## HKS700E SERVICE LETTER

### SL-700-003

Running modification on HKS700E engine.

Fig 1

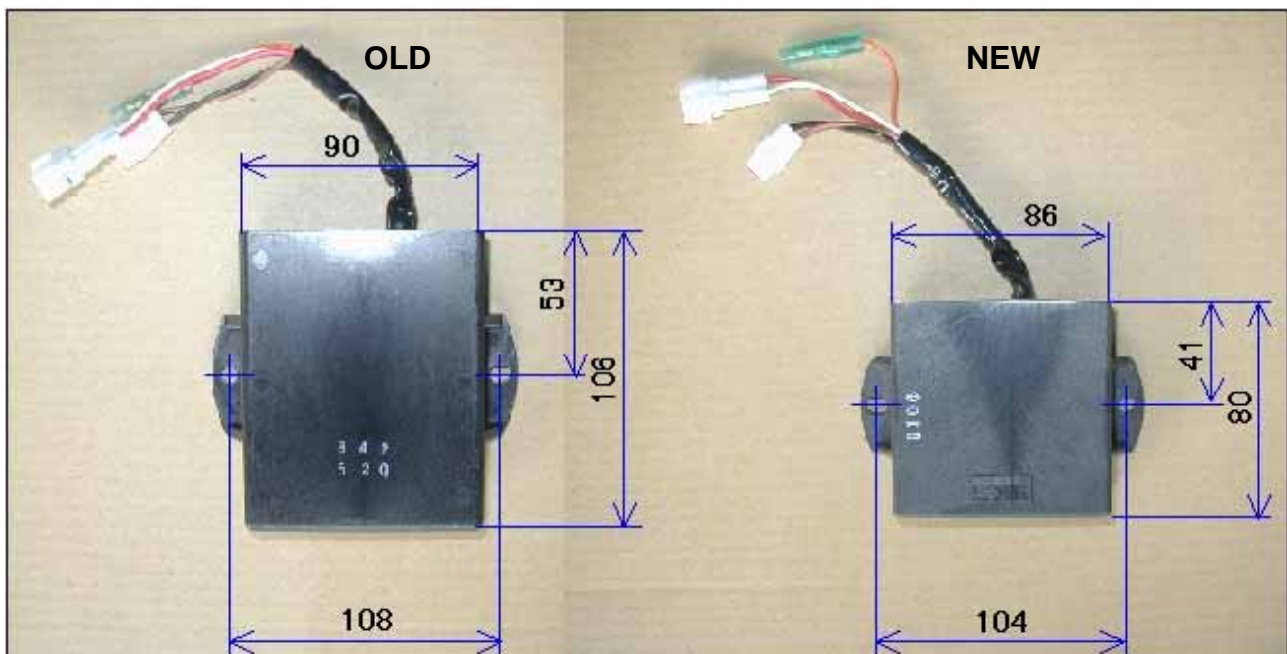
Introduction of new CDI UNIT. (see Fig 1)

The new CDI UNIT is interchangeable for old CDI UNIT.
